Amendments to the Drawings

Remarks

FIG. 1A

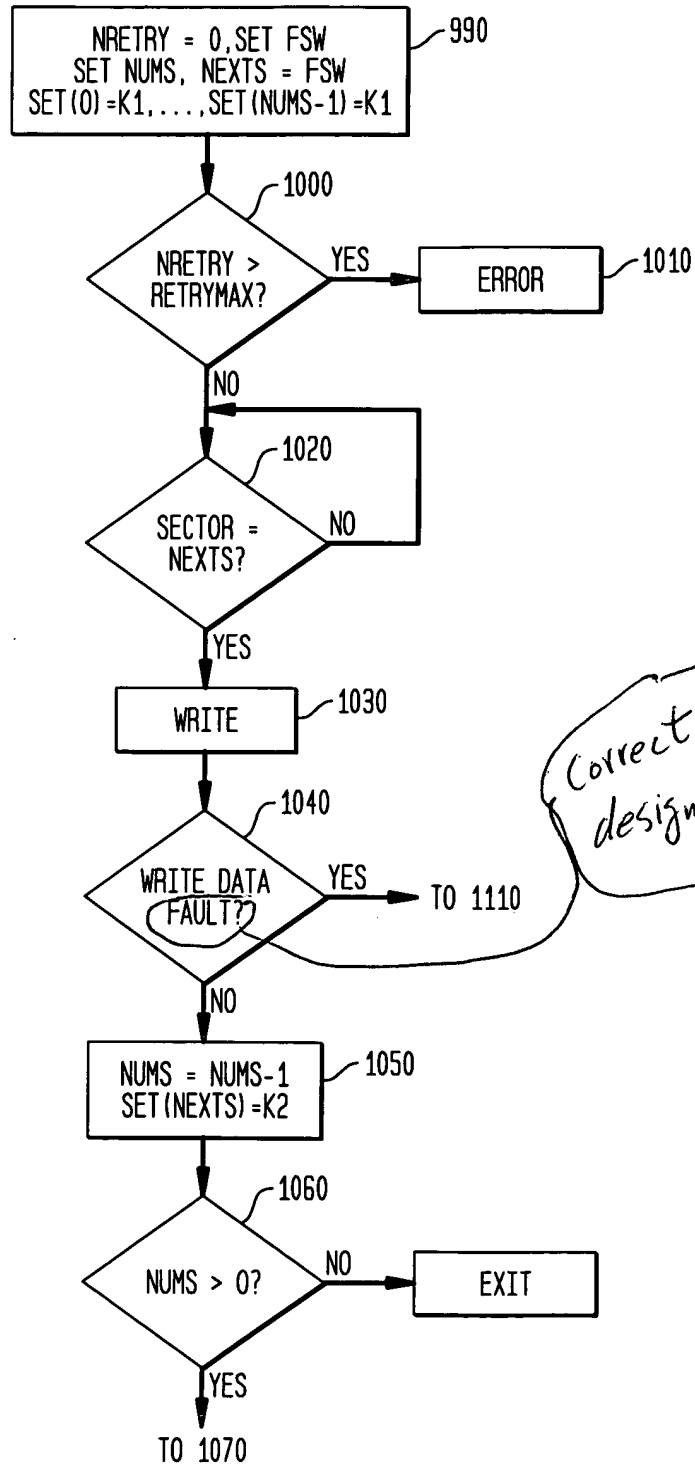
renumbered 1A

Correct previous designation default

FIG. 1B

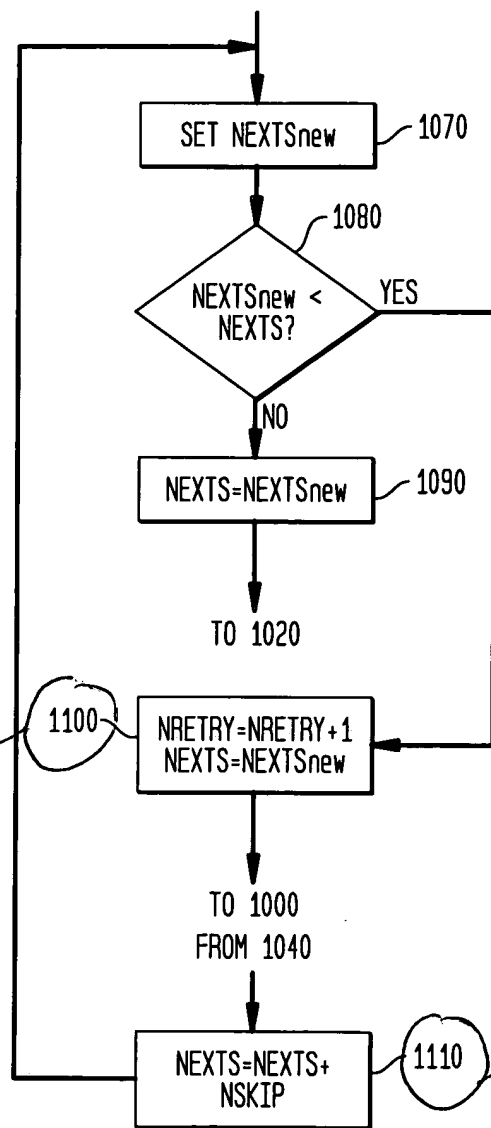
renumbered 1B

add missing
number

add missing
number

FIG. 2A

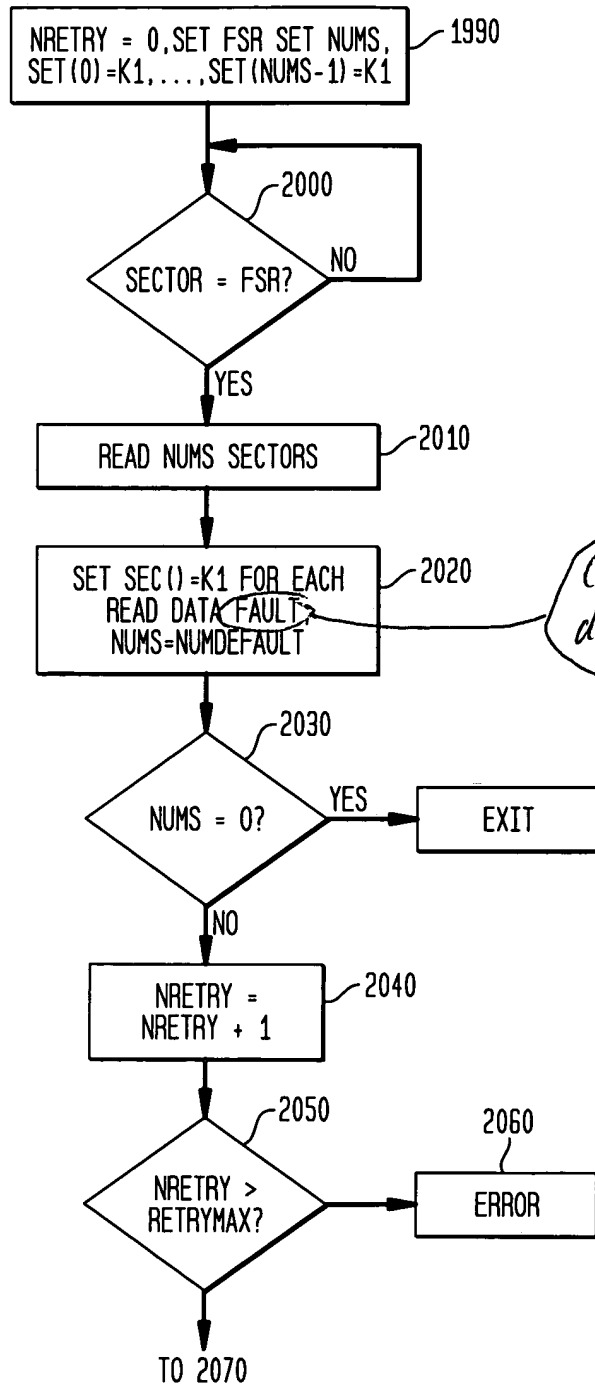
renumbered 2A

FIG. 2B

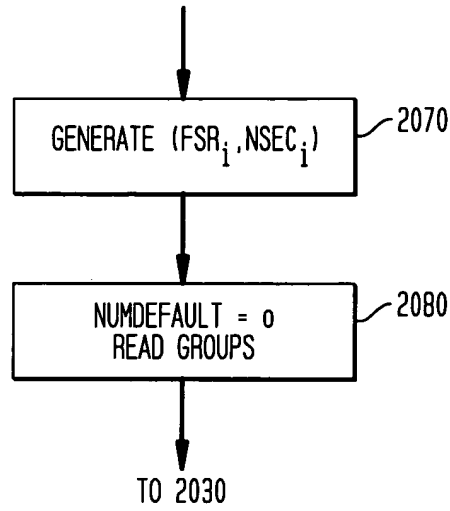
renumbered 2B

FIG. 3A
(PRIOR ART)

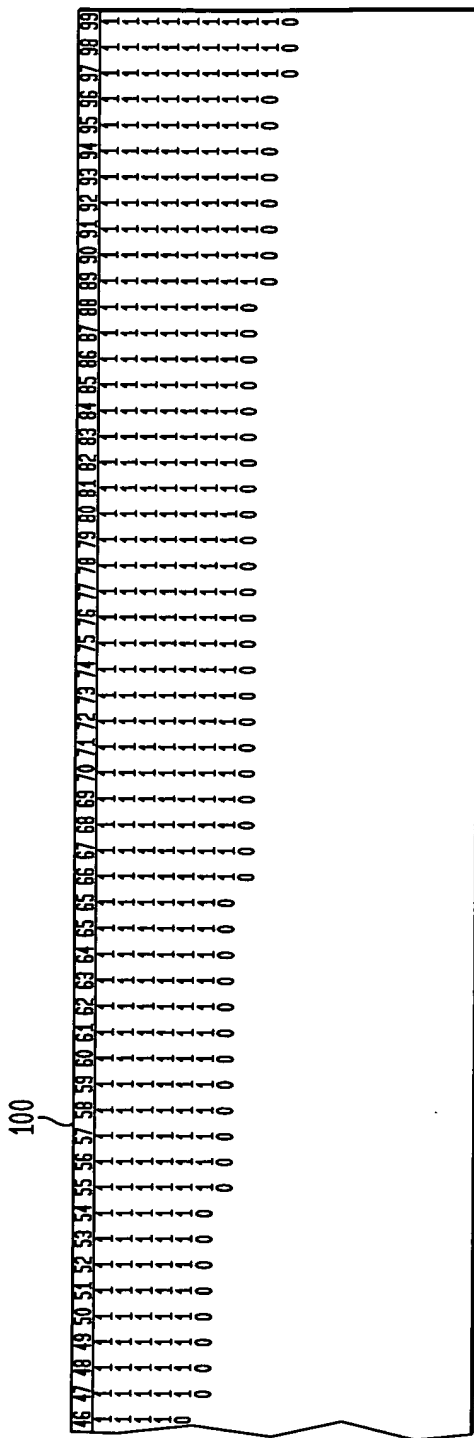
The drawings are objected to because they include sloppy lettering and lines and FIGs. 3 and 4 mix the “Prior ART” with applicant’s invention. It is suggested that the applicant present two separate figures for FIG. 3, as well for FIG. 4, one pertaining to the present invention and the other one labeled as “PRIOR ART”, i.e., FIGs. 3A and 4A “PRIOR ART”. It is also suggested that the applicant review all the submitted drawings for errors (i.e. page 4, paragraph 0016, line 6, “box 1110” of specification).

renumbered 3A

Added Label Prior Art

FIG. 4B

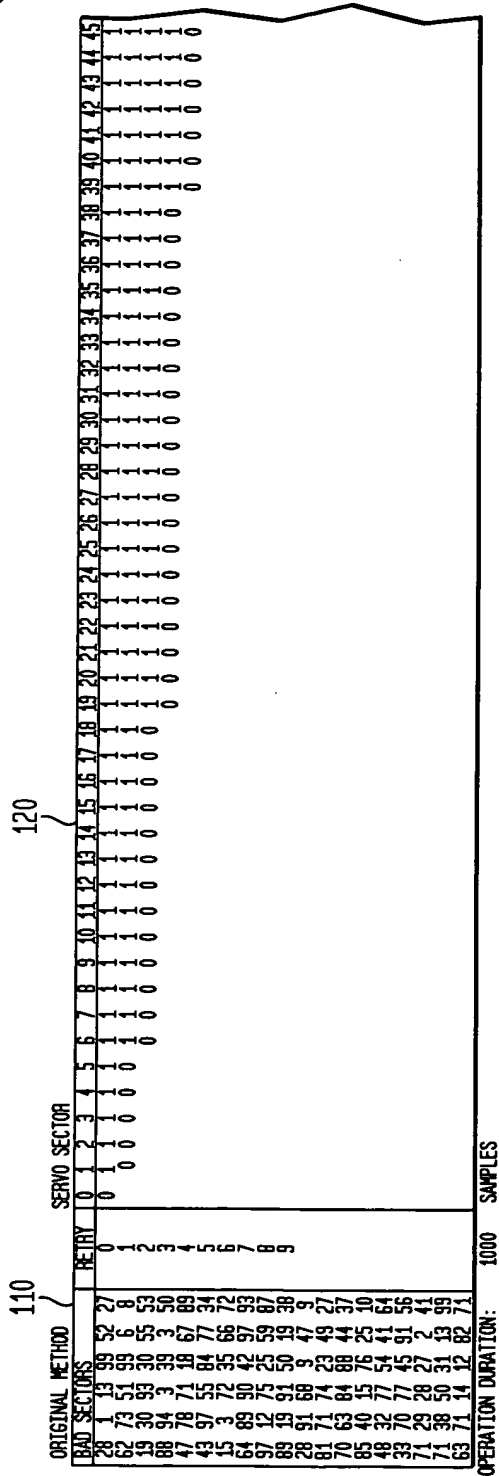
renumbered 4B
